Section 16 Planning Application for Proposed Minor Relaxation of Gross Floor Area and Building Height Restrictions for Permitted Office Use and Other Permitted Uses in "Commercial (7)" Zone bounded by King's Road and Taikoo Shing Road, Quarry Bay (Application No. A/H21/160)

Departmental comments and public comments were received via District Planning Office / Hong Kong, Planning Department, and the Board in May 2026. In response to the departmental comments and public comments received, the Applicants hereby submit the responses-to-comments tables, with the following attachments for the Board's consideration:-

Responses to Departmental Comments

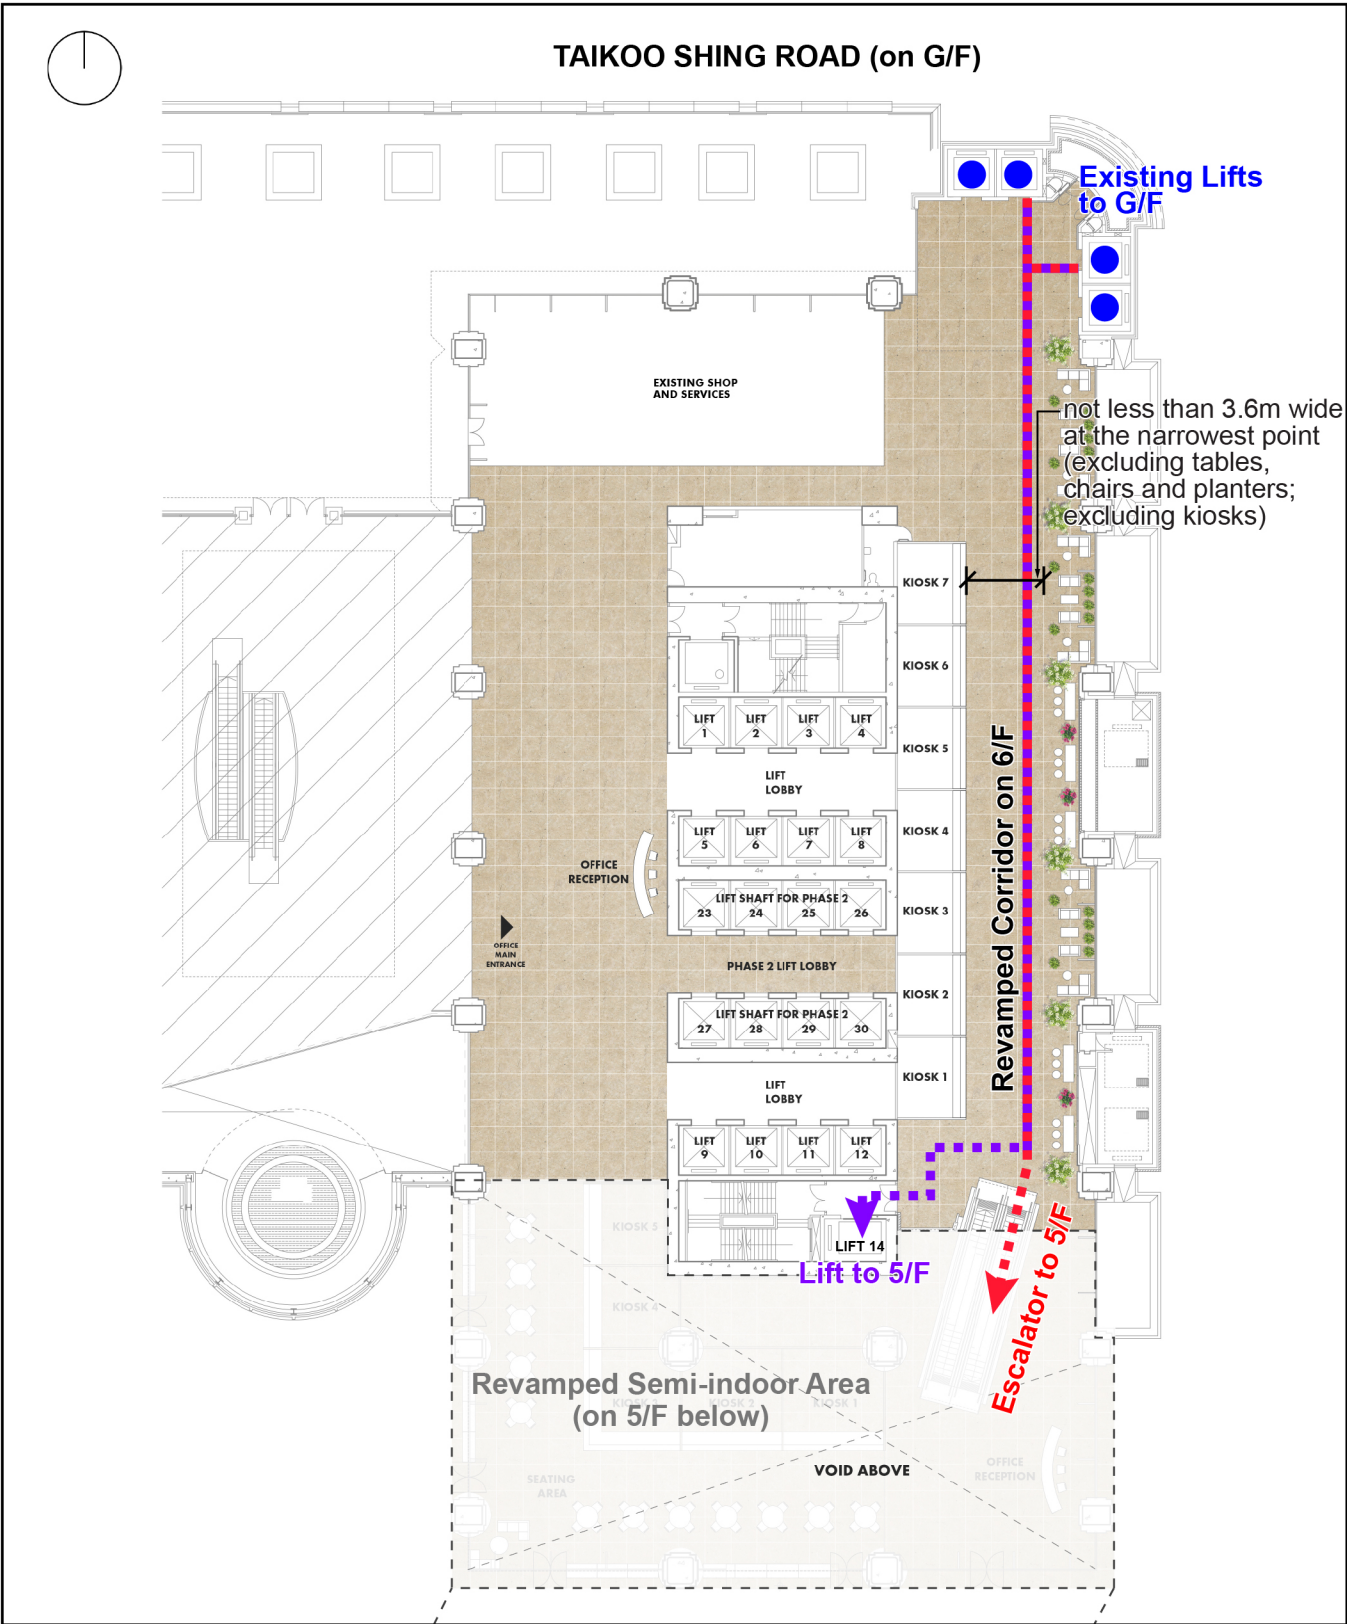
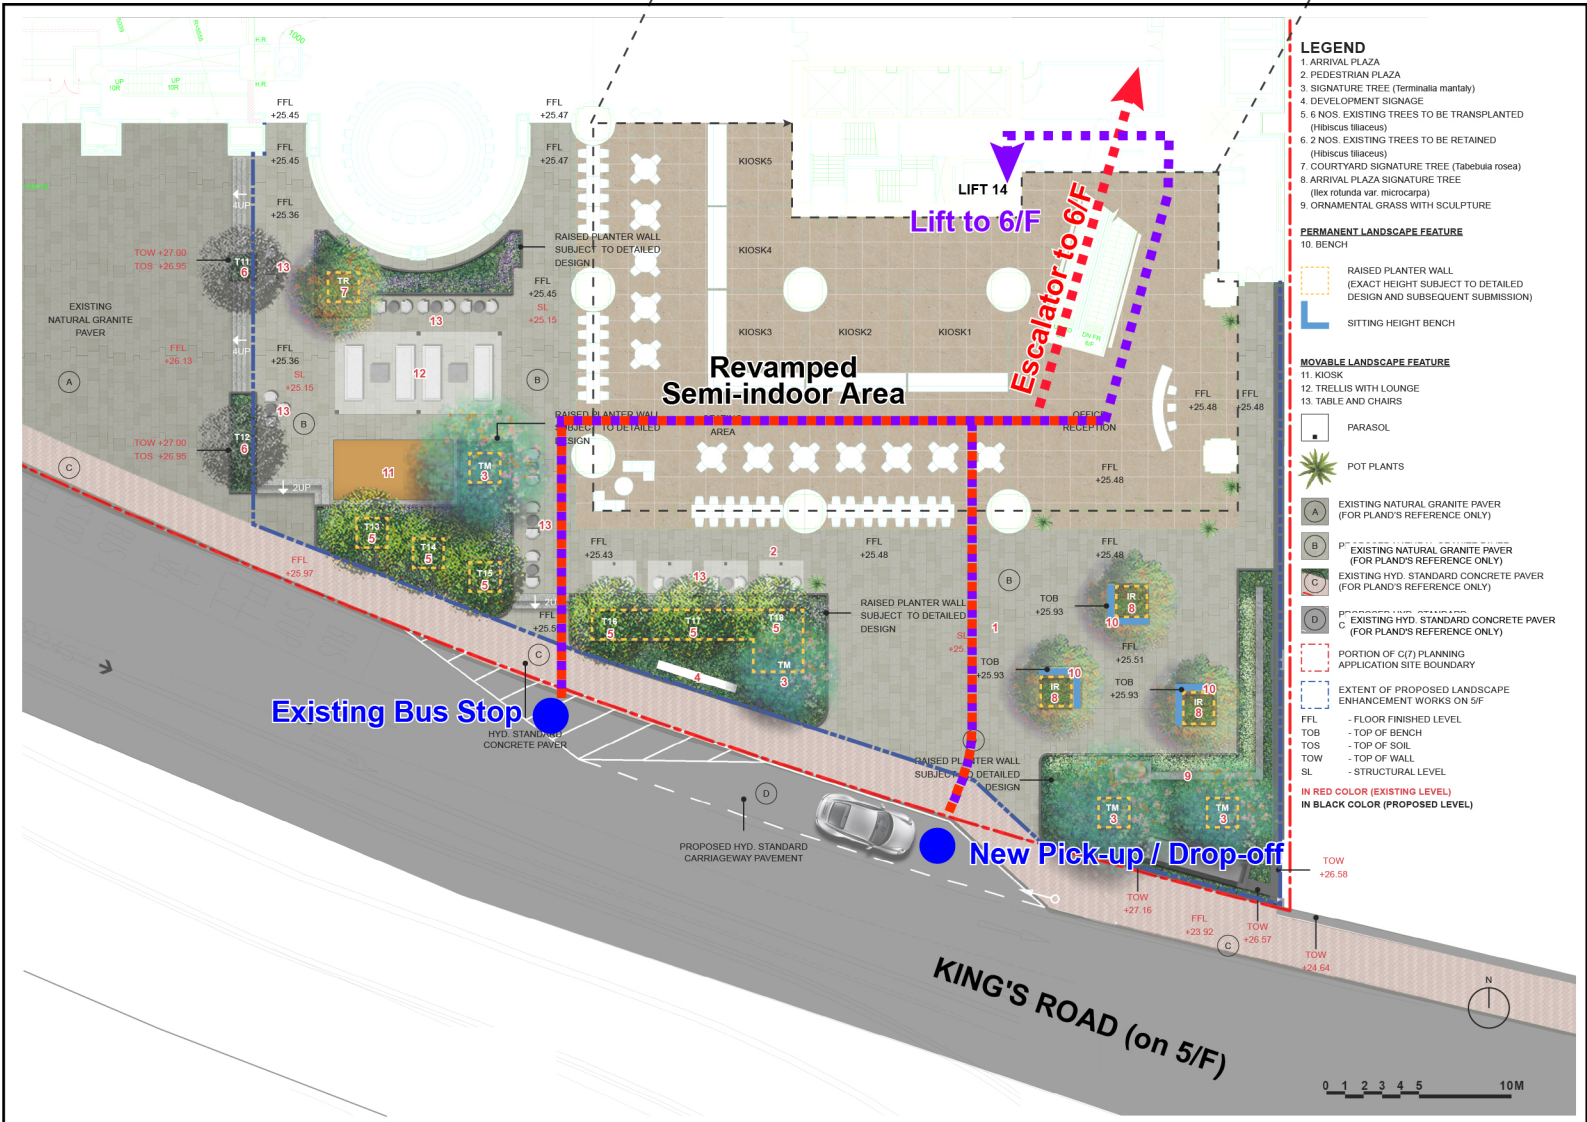
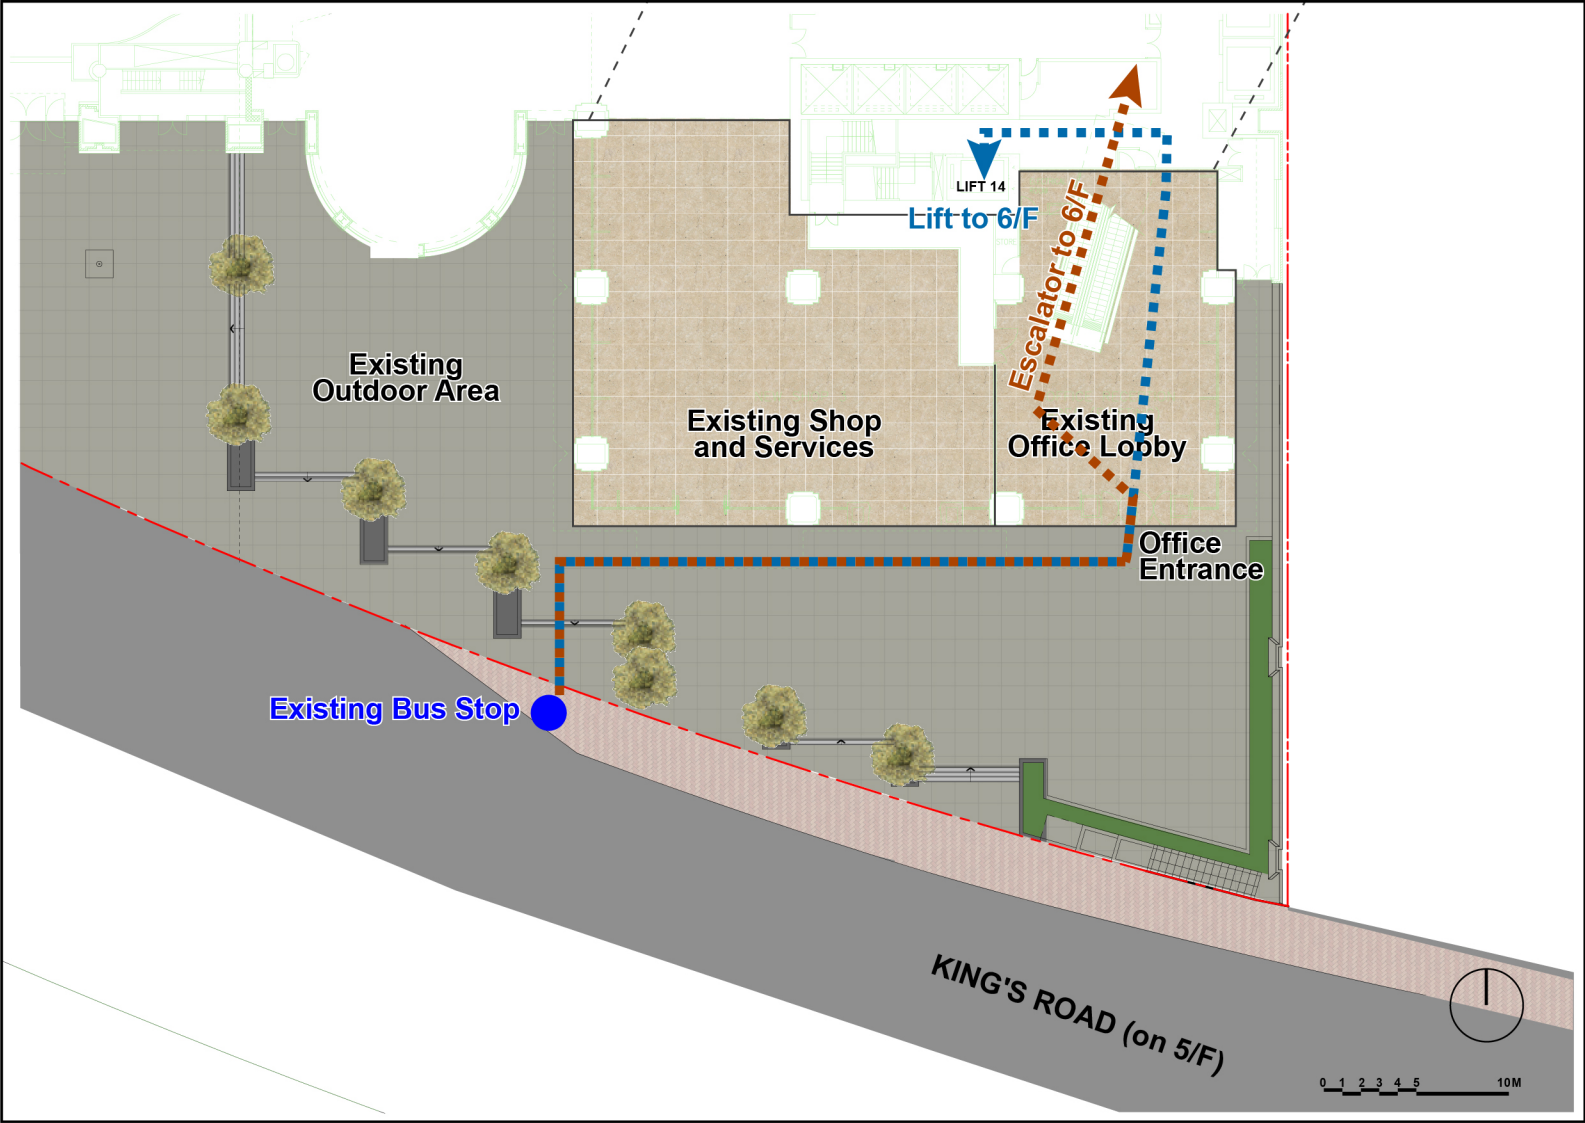
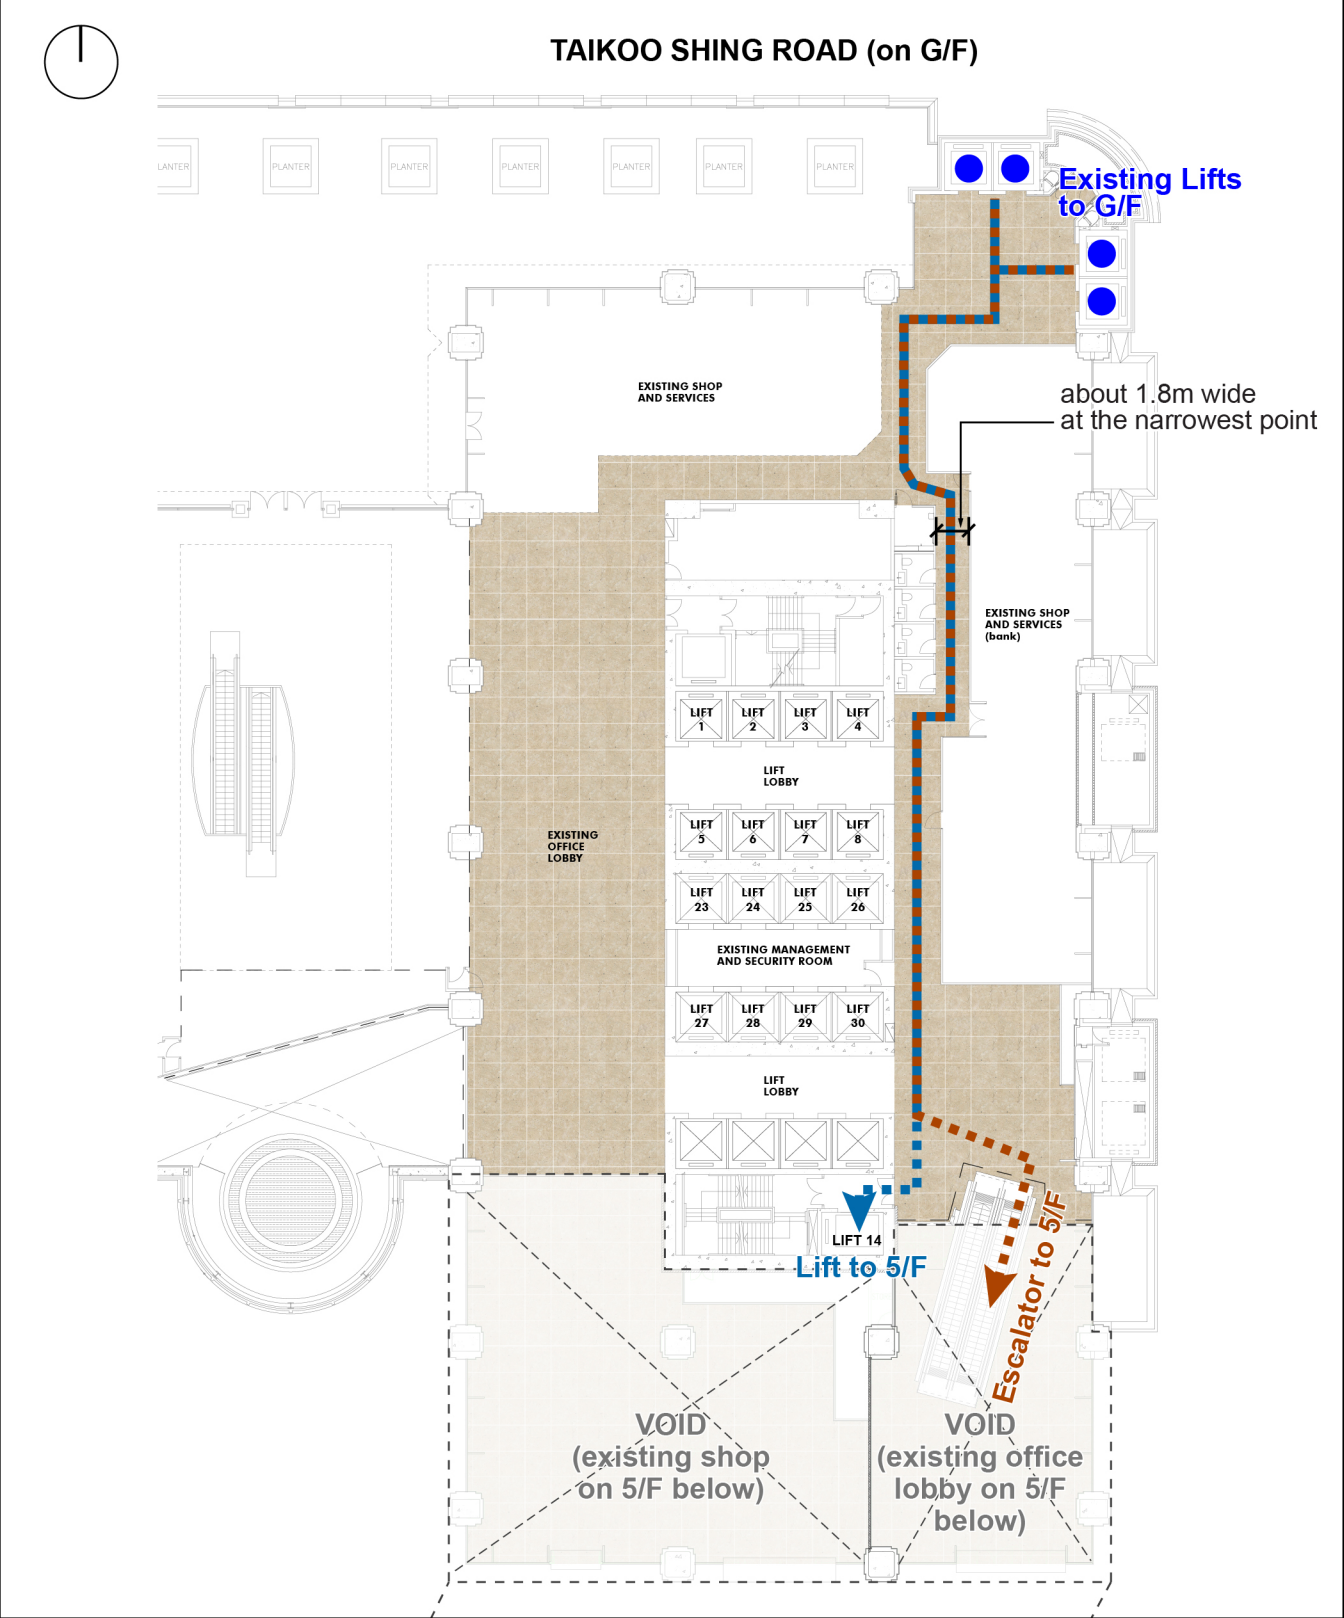
2.4	Figure 3.6 of the PS - The applicants are advised to provide a plan showing the current internal layout of 5/F and 6/F and illustrating the existing pedestrian circulation route between the southern entrance lobby and the 6/F shuttle lift lobby to G/F for better understanding of the proposed improvement of the pedestrian connectivity.	A new Figure 3.7 has been prepared. Please refer to the revised Planning Statement (see Attachment 1).

3 Visual Conditions of Viewing Points

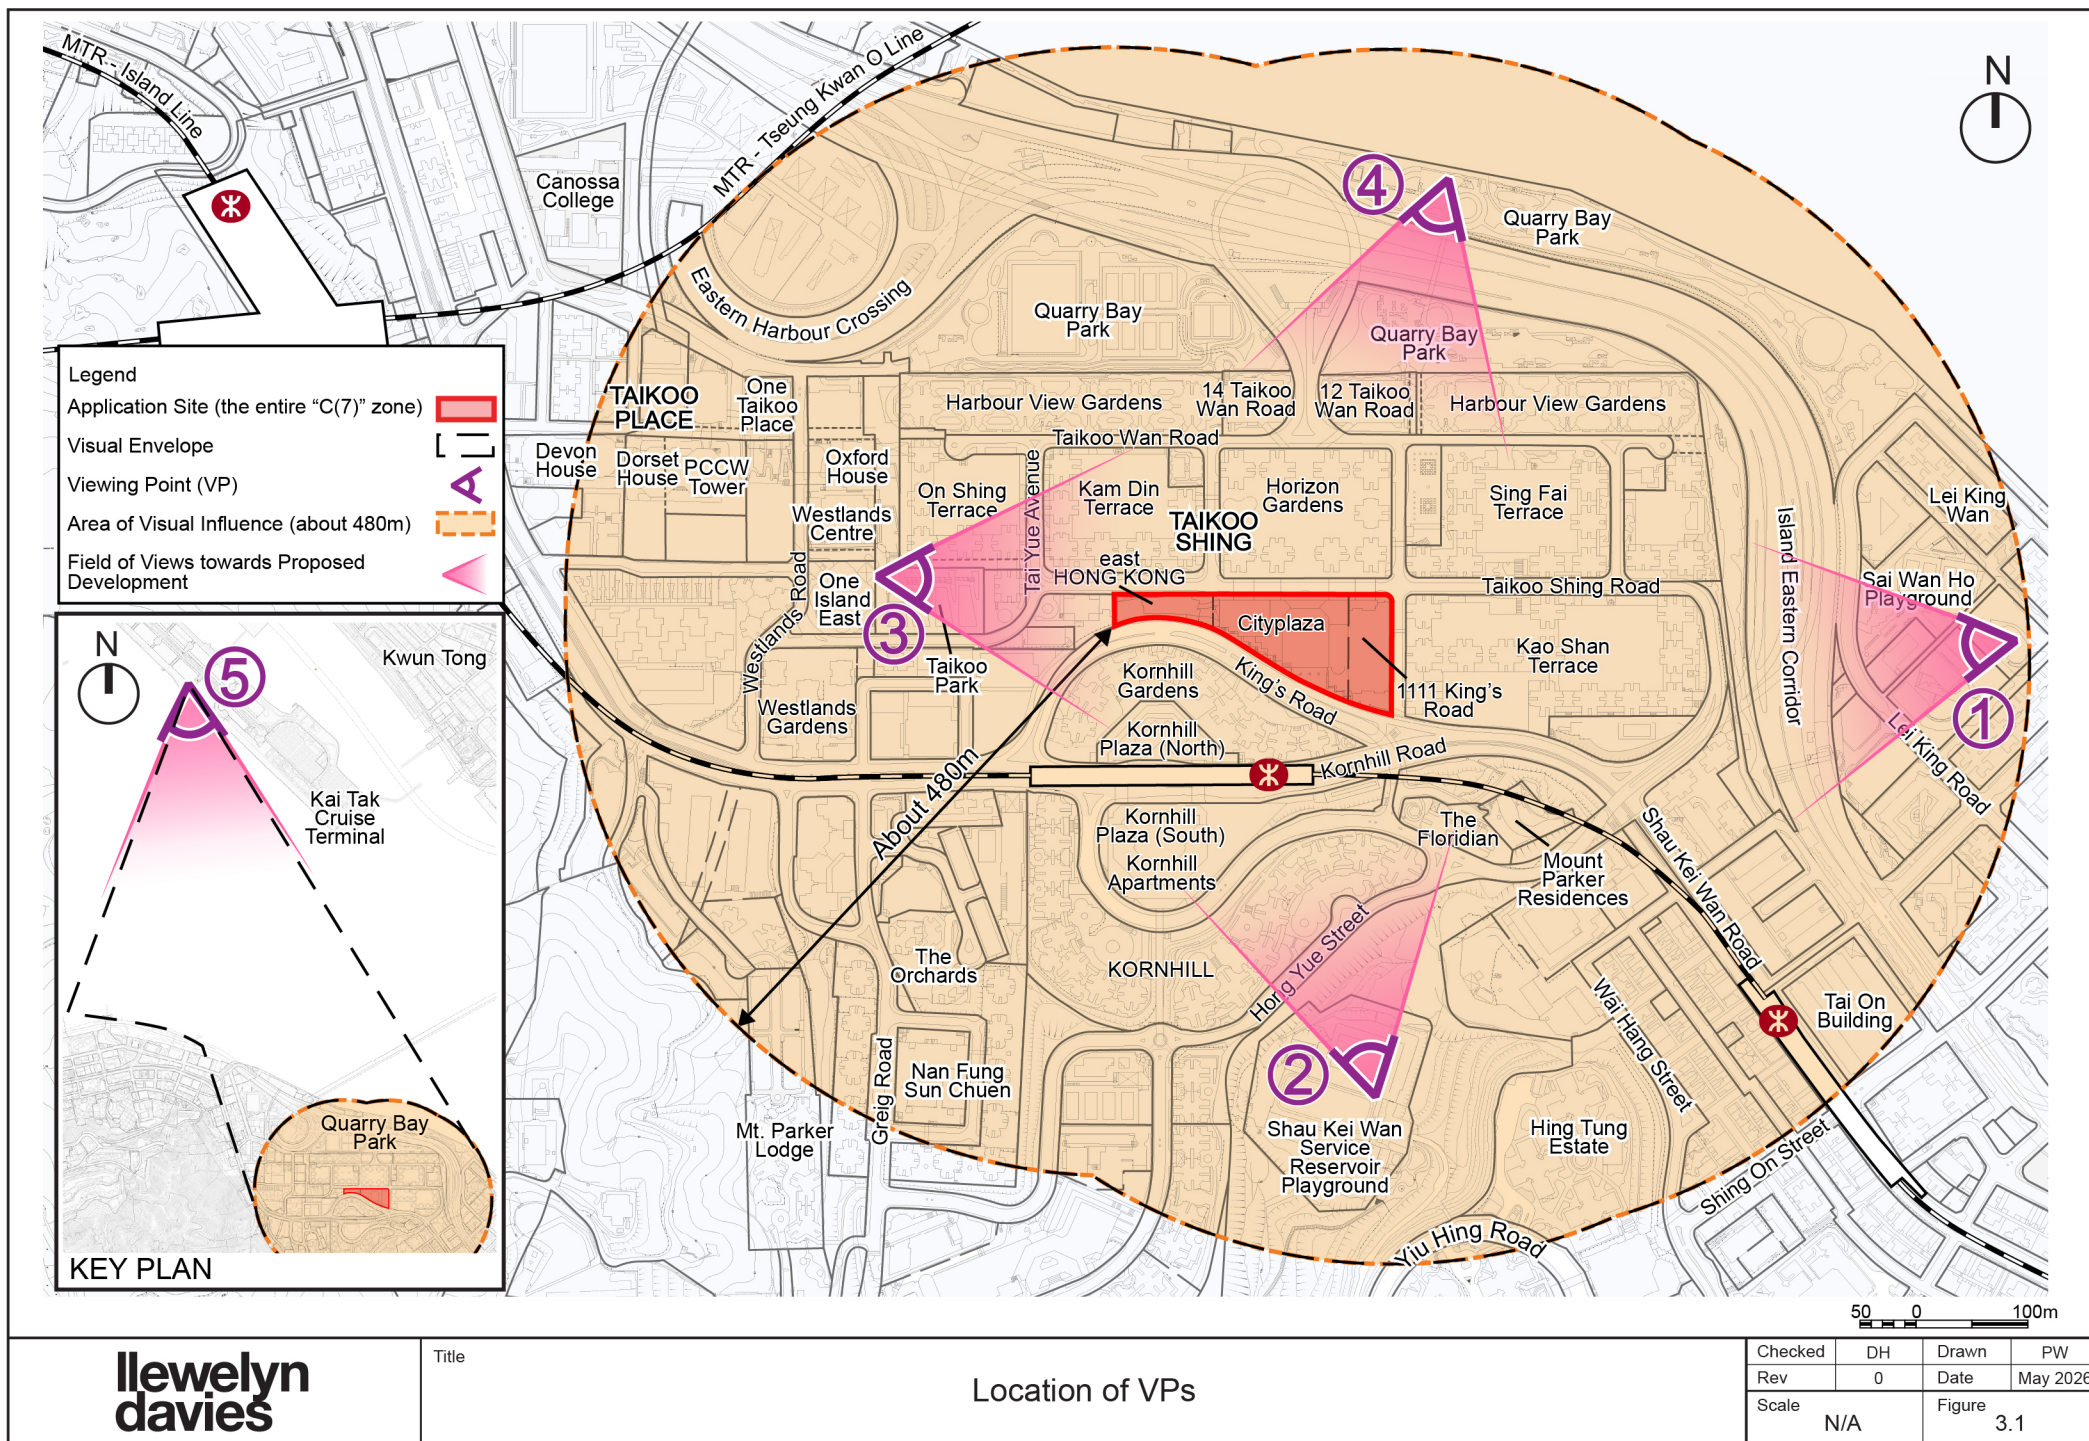
3.	Comments from Urban Design Section, Planning Department	
3.1	Item No. 6.1 of the R-to-C - Visual envelope in the VIA is still missing.	Having regard to the urban context with existing high-density and high-rise developments in the surrounding area, there is only limited view towards the Proposed Development from the identified vantage points. The visual envelope is, in effect, equivalent to the area of visual influence for this case, except that the visual envelope also covers the view from the waterfront promenade at Kai Tak Development, from which the top floors of the Proposed Development will be visible from a remote distance. Figure 3.1 and relevant paragraph of the VIA has been updated (see Attachment 2).
